**HISTORIC AND DESIGN REVIEW  
COMPLIANCE AND TECHNICAL ADVISORY BOARD**

**November 22, 2024**

**HDRC CASE NO:** 2024-361  
**ADDRESS:** 915 MASON ST  
**LEGAL DESCRIPTION:** NCB 1267 BLK 3 LOT S 105 FT OF 7  
**ZONING:** R-6, H  
**CITY COUNCIL DIST.:** 2  
**DISTRICT:** Government Hill Historic District  
**APPLICANT:** Chad Bradshaw/Mychal's Designs LLC  
**OWNER:** Sevda Johnson/SEVHAS INVESTMENTS LLC  
**TYPE OF WORK:** Wholesale window replacement  
**APPLICATION RECEIVED:** October 18, 2024  
**60-DAY REVIEW:** December 17, 2024  
**CASE MANAGER:** Bryan Morales

The applicant is requesting a Certificate of Appropriateness for approval to replace all existing windows onsite with aluminum windows featuring internal faux muntins.

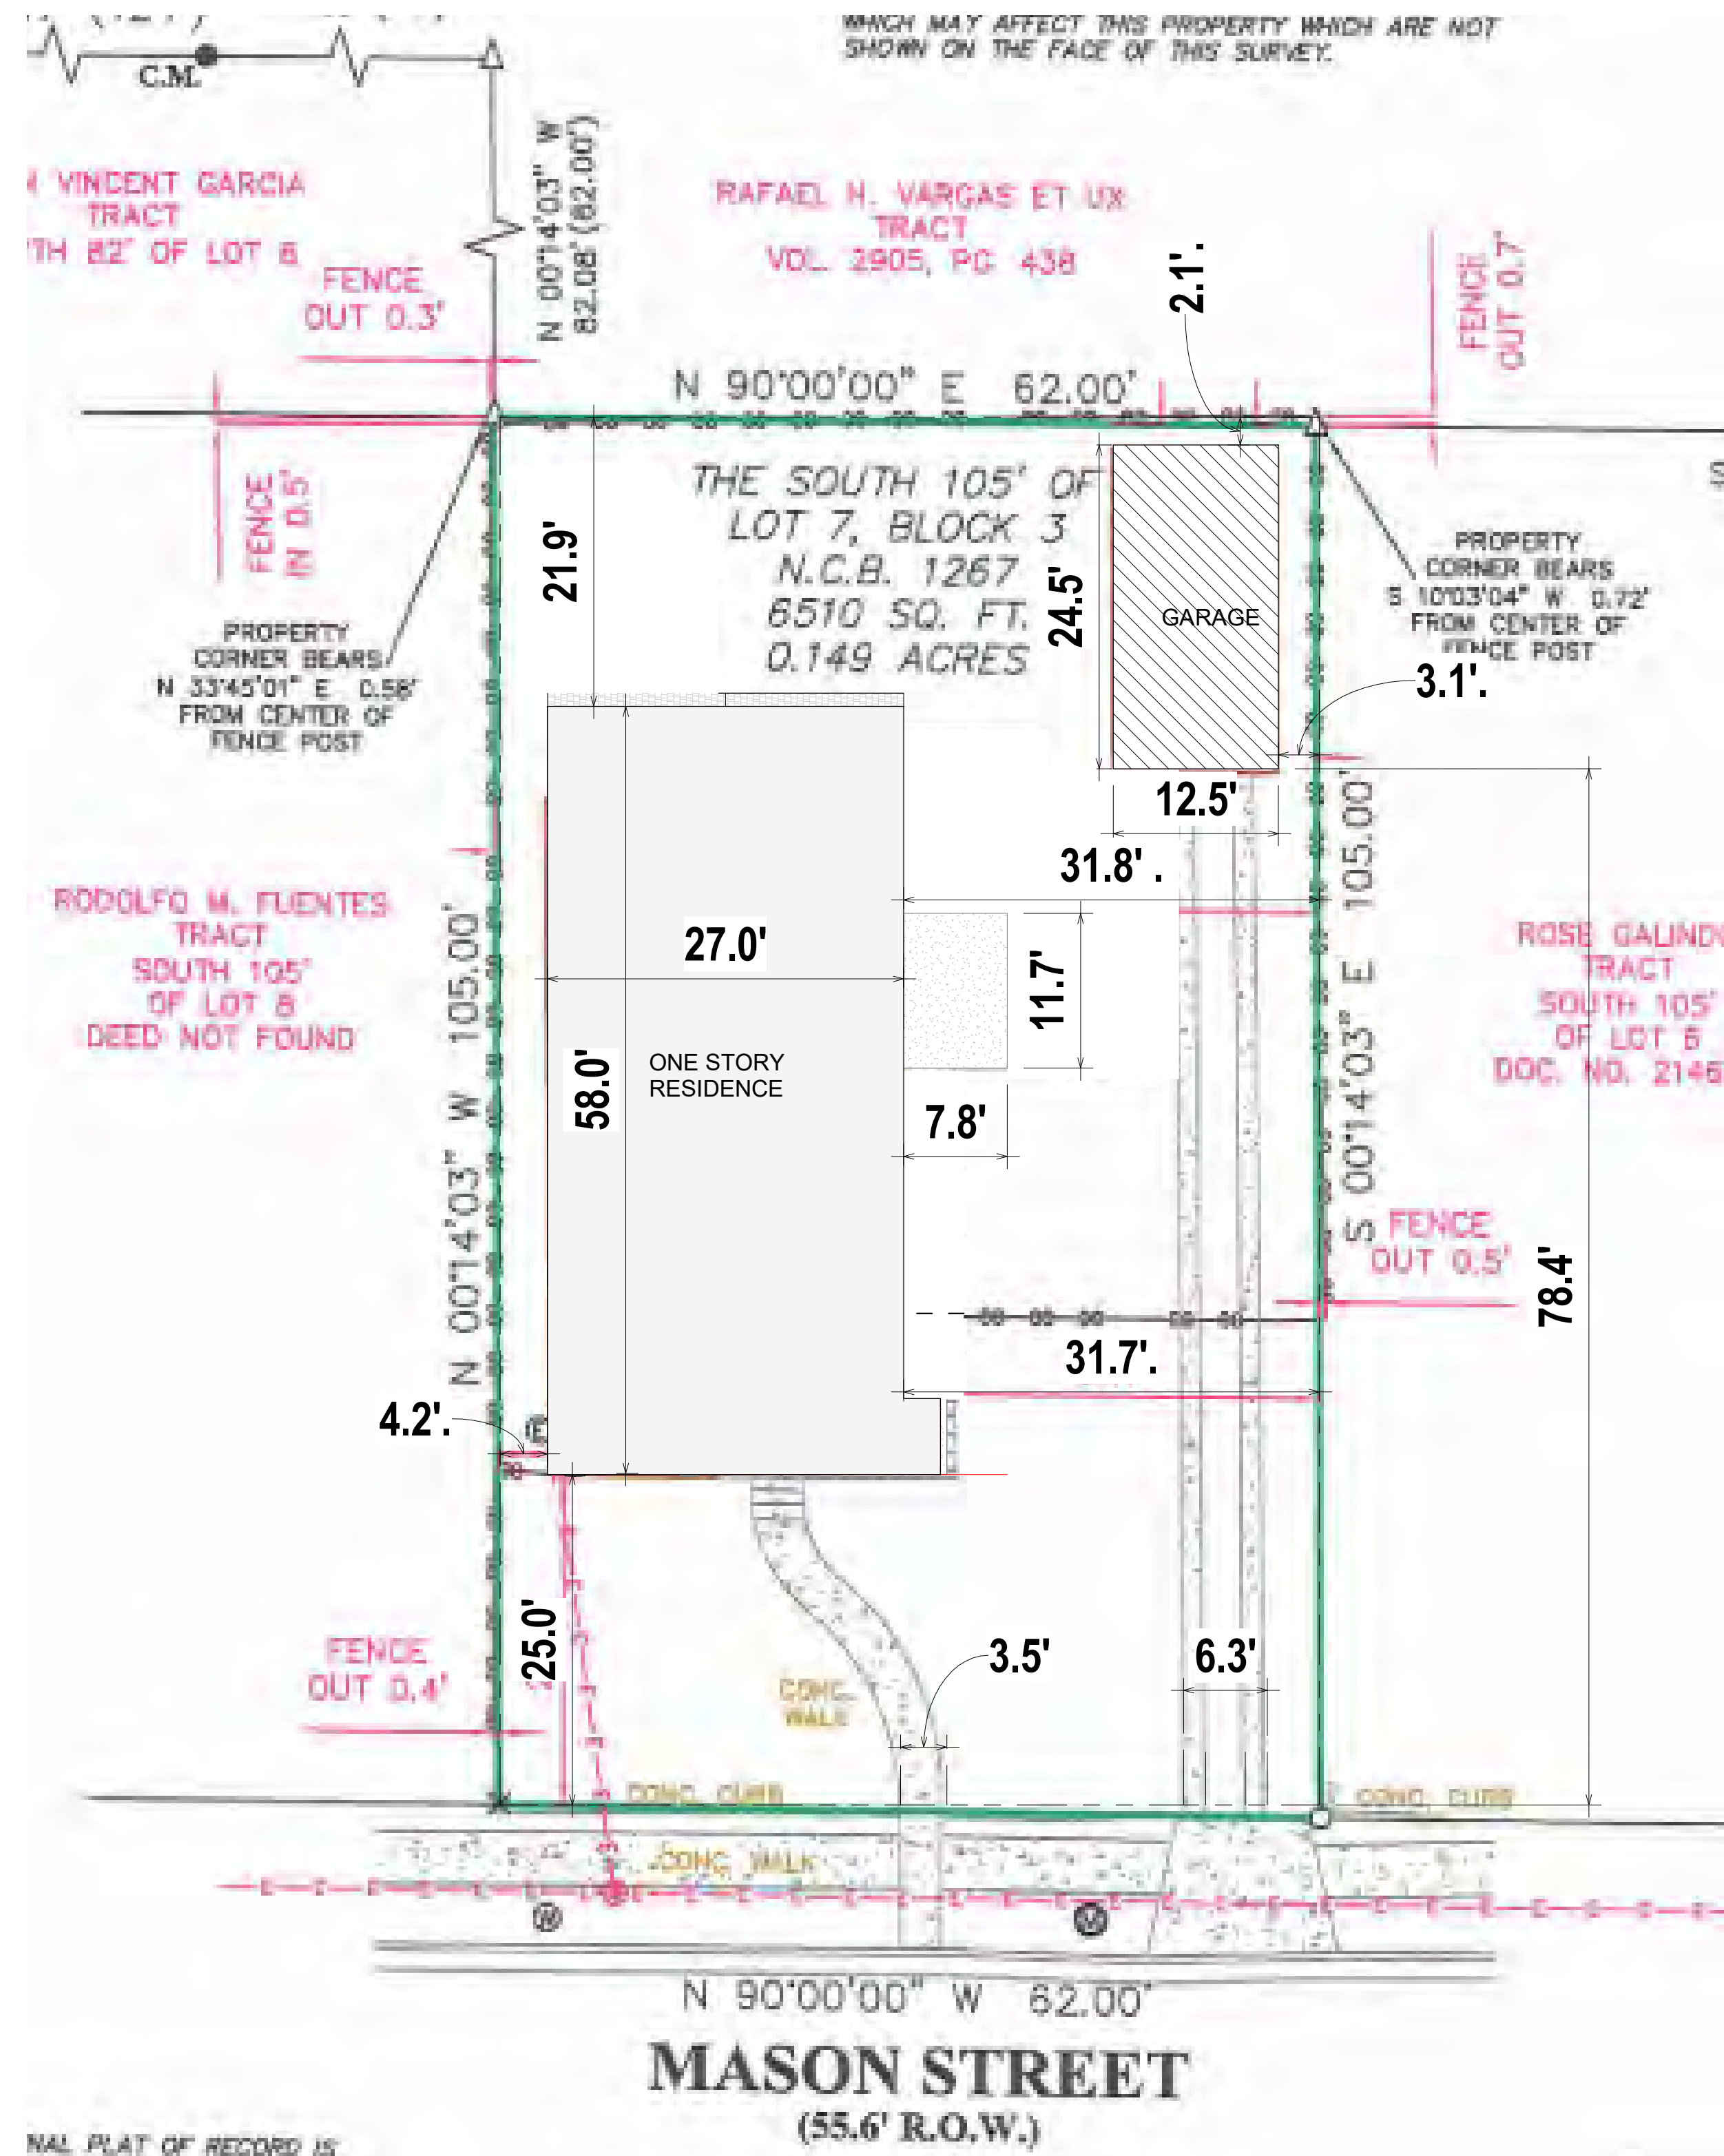
- v. *Muntins*—Use the exterior muntin pattern, profile, and size appropriate for the historic building when replacement windows are necessary. Do not use internal muntins sandwiched between layers of glass.

- c. WINDOW REPLACEMENT – The applicant has proposed to replace all existing windows with new aluminum windows featuring faux muntins per the submittal documents. According to the Historic Design Guidelines, wood windows should be repaired in place and restored whenever possible, unless there is substantial evidence that the windows are deteriorated beyond repair. If a window assembly is deemed irreparable, the window should be replaced in-kind in terms of materiality, configuration, inset, proportion, style, and detailing. Staff does not find the window replacement consistent with the Guidelines.

Staff does not recommend approval of the request, based on the findings. Staff recommends the applicant install salvaged or new wood windows that meet staff's standard window stipulations.
